APPLICATION NO.	FILING DATE	FIRST NAMED INVENTOR	ATTORNEY DOCKET NO.	CONFIRMATION NO.
10/807,336	03/24/2004	William A. Peterson JR.	051252-5050-03	3493
7590	01/26/2010		EXAMINER	
SEIMENS CORPORATION INTELLECTUAL PROPERTY DEPARTMENT 170 WOOD AVENUE SOUTH ISELIN, NJ 08830			MCGRAW, TREVOR EDWIN	
			ART UNIT	PAPER NUMBER
			3752	
			MAIL DATE	DELIVERY MODE
			01/26/2010	PAPER

Office Action Summary	Application No. 10/807,336	Applicant(s) PETERSON, WILLIAM A.
	Examiner Trevor E. McGraw	Art Unit 3752

DETAILED ACTION

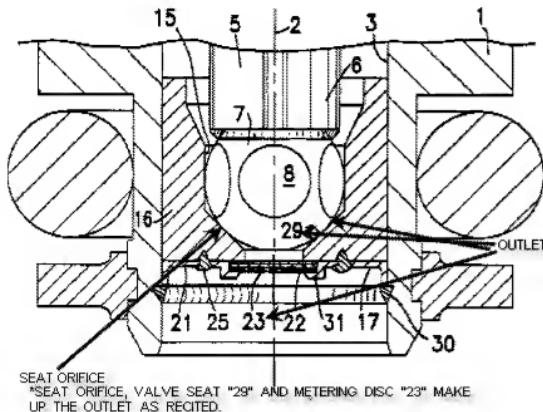
Claims 23-27 are rejected under 35 U.S.C. 102(b) as being anticipated by Arndt et al (US 5,766,441).

In regard to Claim 23, Arndt et al teach a method of controlling a spray of fuel through at least one metering orifice of a fuel injector (column 3, lines 53-55), the method comprising providing the fuel injector (column 3, lines 53-55) having an inlet (inlet that supplies fuel to the injection valve) and an outlet (see first figure provided below) and a passage (3) extending along a longitudinal axis (2) therethrough, the outlet having a seat (29) and a metering disc (23), the seat (29) having a seat orifice (see "seat orifice" in the first figure provided below) and a first channel surface extending obliquely to the longitudinal axis (see curved surface of "35" that serves at the first channel surface in Figures 21 and 22 where the first surface of the flow channel between "36" and "38" is not parallel or perpendicular to the longitudinal axis "2"; see second Figure below), the metering disc (23) including a second channel surface (see surface of "37" in relation to the surface of "35" in Figure 21) confronting the first

channel surface ((see curved surface of "35" that serves as the first channel surface in Figures 21 and 22 where the first surface of the flow channel between "36" and "38") so as to provide a flow channel (channel between "36" and "38") that is separate from but in communication with the seat orifice (see "seat orifice" in the first figure provided below), the metering disc (23) having a plurality of metering orifices (38) extending therethrough along the longitudinal axis (2) and located about the longitudinal axis (2), the metering orifices (38) being in communication with the flow channel, locating all of the metering orifices (38) on a first virtual circle (see Figure 31 where "38" is shown on a virtual circle) outside of a second virtual circle formed by a virtual extension of a sealing surface of the seat (seat as shown in Figure 1) on the metering disc such that each of the metering orifices extends generally parallel to the longitudinal axis through the metering disc and imparting a radial velocity to the fuel flowing from the seat orifice through the flow channel (channel between "36" and "38") so that fuel flows in transverse direction across and through the fuel metering orifices (38; see where flow travels transverse and out of "38" in Figures 4-8 and 10).

First Figure

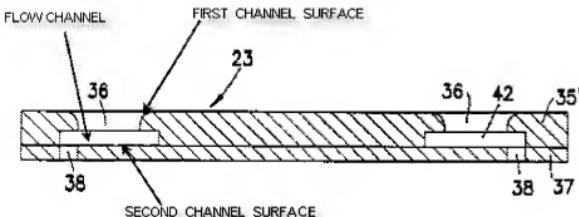
In regard to Claims 24-27, Arndt et al also teach where the locating of the metering orifices (38) includes spacing a first metering orifice (first "38" on virtual circle) at a first arcuate distance relative to a second metering orifice (second "38" on virtual circle) on the first virtual circle (as shown in Figure 31) and the imparting of a radial velocity to the fuel flow includes configuring the flow channel (channel between "36" and "38") to extend between a first position and a second position, the first position being located at a first distance (distance of "36" from axis) from the longitudinal axis and at a

first spacing along the longitudinal axis relative to the second surface of the metering disc (bottom part of "23") and the second position being located at a second distance from the longitudinal axis and a second spacing along the longitudinal axis from the second surface of the metering disc (bottom part of "23"), such that a product of the first distance and first spacing is generally equal to a product of the second distance and a second spacing where the imparting increases and decreases the radial velocity between the seat orifice and each of the metering orifices (distances closer together increase the radial velocity and distances further apart decrease the radial velocity as shown in the Figures of Arndt et al.).
